ALTAMONT ZONING BOARD OF APPEALS
Regular Meeting Agenda
April 23, 2024
Altamont Community Room – 7:00 p.m.

1. Open meeting - State time and that the meeting is being recorded and where the exit signs are located.
2. Topic & Discussion: Continuation of Public Hearing for CM Fox Living Solutions LLC (Troy Miller) for Major Subdivision. Property at S.B.L. 37.14-3-6.1.
3. Other Business: _____

CM FOX LIVING SOLUTIONS LLC
 MAJOR SUBDIVISION
 11 WESTERN AVE.
 ALBANY, NY 12240
 NEW YORK STATE
 CHECKED BY: [Signature]
 DATE: 11/13/13
 SHEET 1 OF 12
 C-150

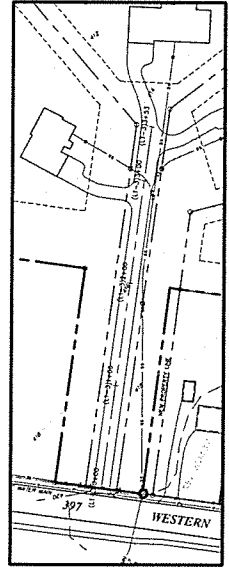
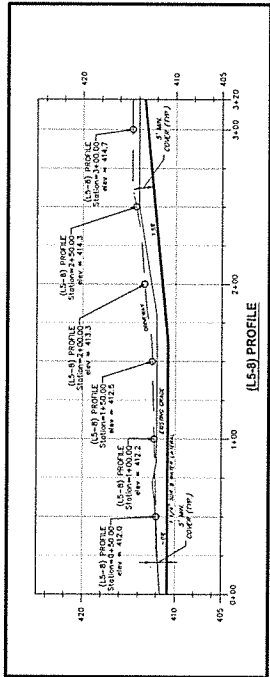
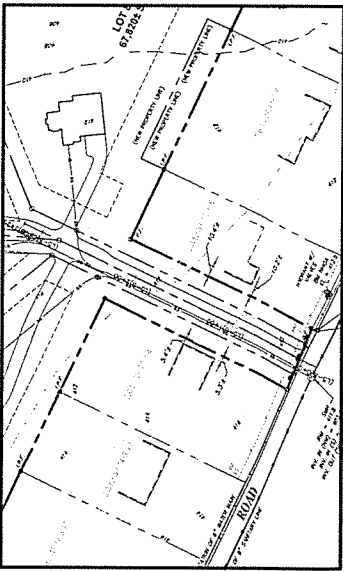
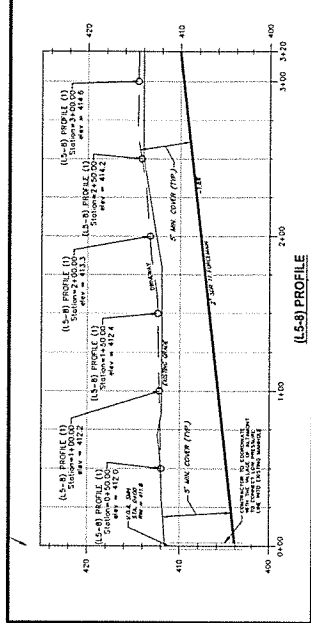
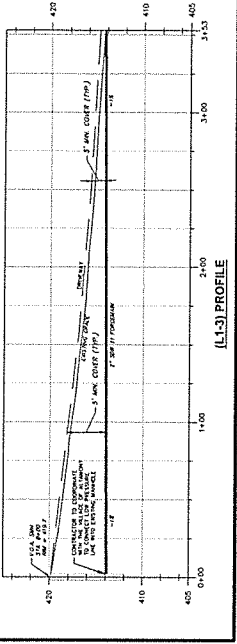
2. Provide a profile of each driveway that considers drainage, culverts and conveyance of runoff. Show water and sewer laterals with appropriate cover as already detailed.

Please refer to sheet C-150 Plan & Profile for utility information within common access driveway.

1 **LOTS 1-3 COMMON DRIVEWAY WITH SWALE CROSS SECTION**
SCALE: 1"=5'

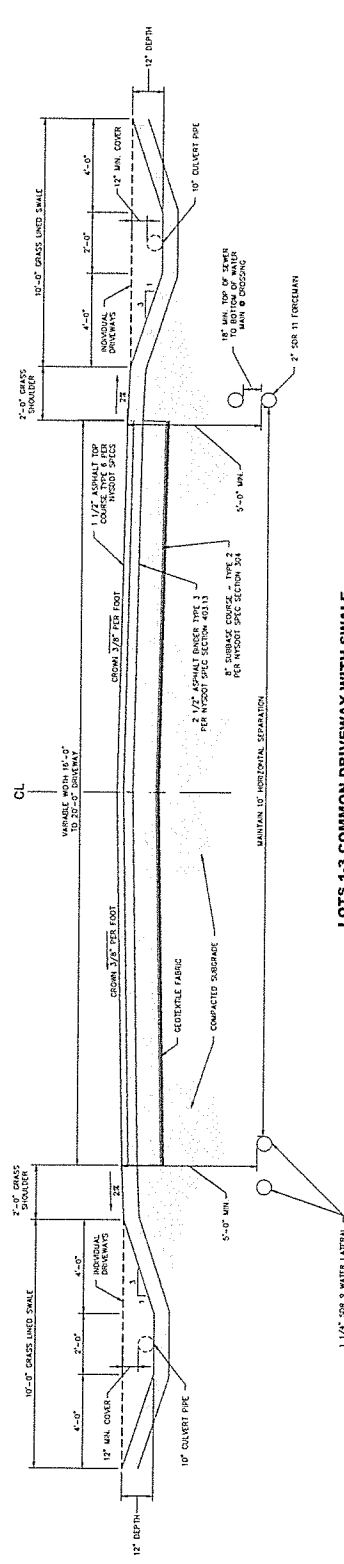
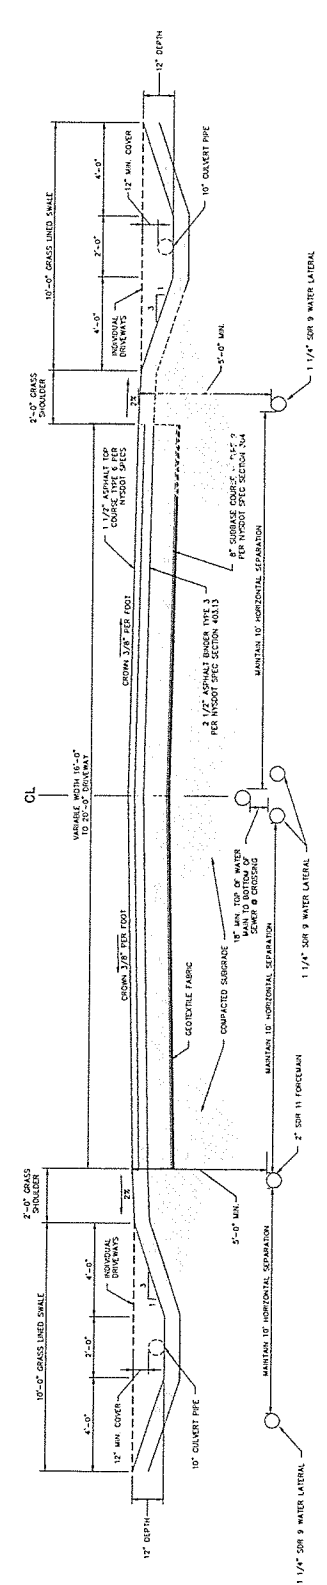
2. For detail 7 (drainage swale) we recommend 1 vertical: 3 horizontal side-slope to less erodible than 1:2 shown.

3. Is there a more resilient grass seed mix than just rye grass that could be more heat and erosion resistant for detail 7?

Please see sheet C-500, detail 7 for revised side slope note.

NYS DOT Seed Mix A would work well in these low shade areas, please see sheet C-500, detail 7 for revised note.

3 TOPSOIL, FERTILIZER, SEED & MULCH

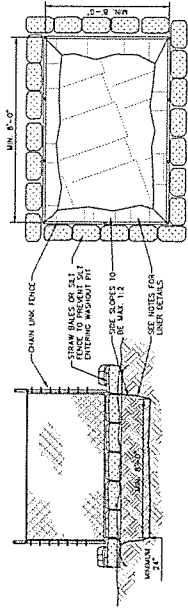
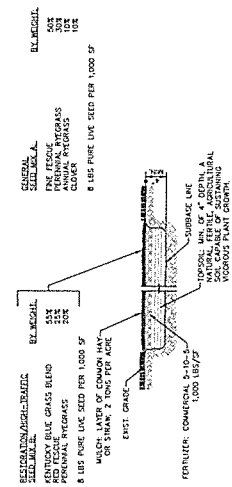
1. Where/what is seed mix A for detail 3?

NYS DOT Seed Mix A was not chosen for this application as it is tailored for general road-side usage, where seed Mix B is a mix of grasses formulated for Restorative/high-traffic areas, please see sheet C-500, detail 3 for more information.
